**NRC/INEL Radiation Therapy
Event Investigation Team
Report 9501**

**Idaho National Engineering Laboratory
Lockheed Idaho Technologies Co.
Idaho Falls, Idaho 83415**

NRC/INEL RADIATION THERAPY EVENT INVESTIGATION TEAM REPORT 9501

Figure 3. Elekta's Proposed Solution

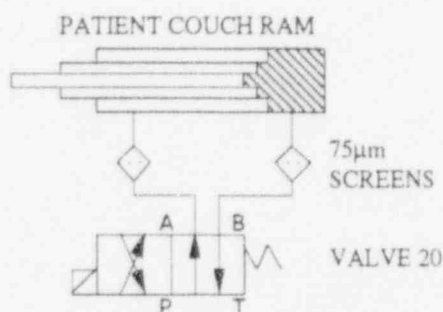
A simplified schematic of the modification of the bed positioning portion of the hydraulic system as proposed by Elekta is shown in Figure 3. The schematic for the door positioning portion of the system is very similar, and is not shown. In the diagram shown, fluid is pumped through the valve and the left screen to the left side of the ram cylinder. The fluid on the right side of the ram cylinder is pushed through the right screen, then through the valve and to the reservoir. When the solenoid is energized, the valve spool moves into the other position (where the lines are shown crossed). The fluid from the pump then leaves the valve on the right side and flows from the right screen to the right side of the ram cylinder. The fluid in the left side of the ram cylinder is forced down through the left screen, through the valve and to the reservoir.

There are two problems with this proposed solution. First, 75 μm is not an adequate filter size for these valves. Second, instead of removing any contaminants from the system, the contaminants stopped by the screens will travel back and forth between the screens and the ram cylinders. The probability that particles (especially metal slivers) will eventually travel through one of the screens to the bed or door position valve is increased each time the fluid flow changes direction and particles are released from the screen.

Figure 4. Recommended Solution

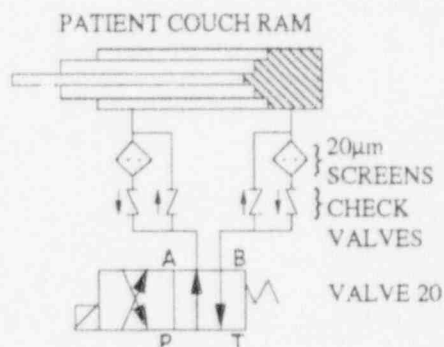
Figure 4 shows the recommended solution for filtering the fluid. Filters are used instead of screens to remove contaminants from the system, instead of allowing them to travel from one screen to the other through the ram cylinder. Hydraulic systems typically use 10–25 μm filters, depending on the level of cleanliness required. Twenty μm filters were chosen based on discussions with a representative of the manufacturer of valve 20. This filter size is also used by the manufacturer of the gamma knife on the return line to the reservoir.

When the control valve is in the position shown, fluid flows from the pump, through the control valve into the left side of the system, through the check valve in the left side bypass, and to the left side of the ram cylinder. The fluid in the right side of the ram cylinder is pushed through the right side of the system and through the filter on the right. The check valve on the right bypass prevents the exiting flow from bypassing the right filter. The fluid then passes through the control valve and returns to the reservoir. When the control valve is put in the other position, the incoming fluid bypasses the right hand filter and the exiting fluid is forced through the left filter. The check valves at the exit of the filters will prevent backflow through the filters.

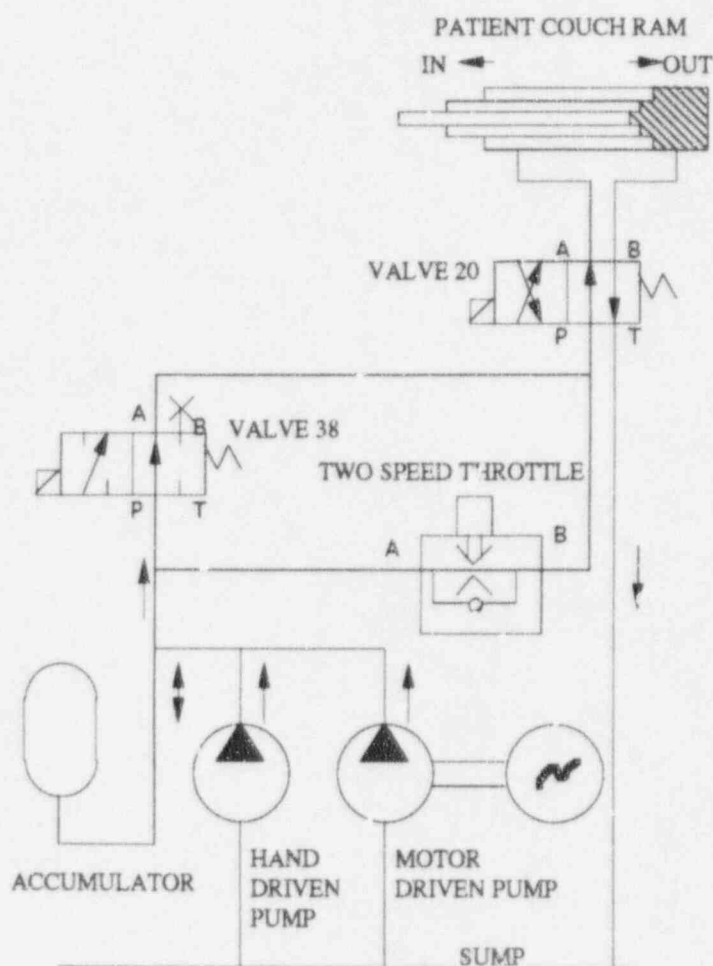
When Stephanie Walker and I reviewed the electrical schematics for the control logic we found an inconsistency. The inconsistency pertains to the operation of hydraulic valve 38. Although, physically, this valve closely resembles the other hydraulic valve; operationally it is connected so that it may be thought of as a simple "open or shut" valve. Valve 38 is on a bypass line around the two-position, speed-control throttle valve on the bed supply line. When valve 38 is open, as shown in the diagram, the fluid will avoid the constriction of the two position throttle valve and flow through the bypass line. The bed will then move in or out of the treatment position more quickly.

From the electrical schematics, we also observe that if the power breaker to the motor-driven pump opens while control power remains to the rest of the system, then the treatment will complete its programmed time. Then the system will withdraw the bed on the accumulator (or hand-driven pump) pressure. The control circuit schematics show that in this case valve 38 remains shut.

If the assumption is true that the purpose of valve 38 is to allow faster retrieval of the bed when only the accumulator or hand-driven pump is available as a fluid source, then it is inconsistent that valve 38 does not open when the pump-motor breaker opens.

We do not claim that this is unsafe, we only point out what appears, with our limited review, to be an inconsistency in the control logic.
